Access Compliance Report Public Rights-of-Way (Pedestrian Signals)

Main Street: FAIRMONT BLVD Cross Street: OLD RANCH RD Location: SE

ADA ID: SGAT210921144837 Signal Type: One Push Button-Non APS Overall Compliance: No Severity Scores: BTN 1: 35 BTN 2: N/A No BTN: N/A

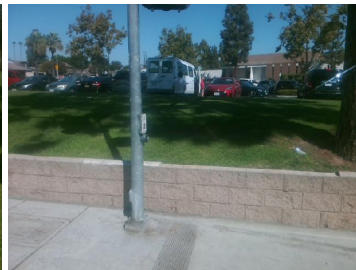
OC Std/PROW: MUTCD 4e.08, R404.2

Possible Solutions: Replace Signal Push Button With APS Button. Remove & Relocate Sign.
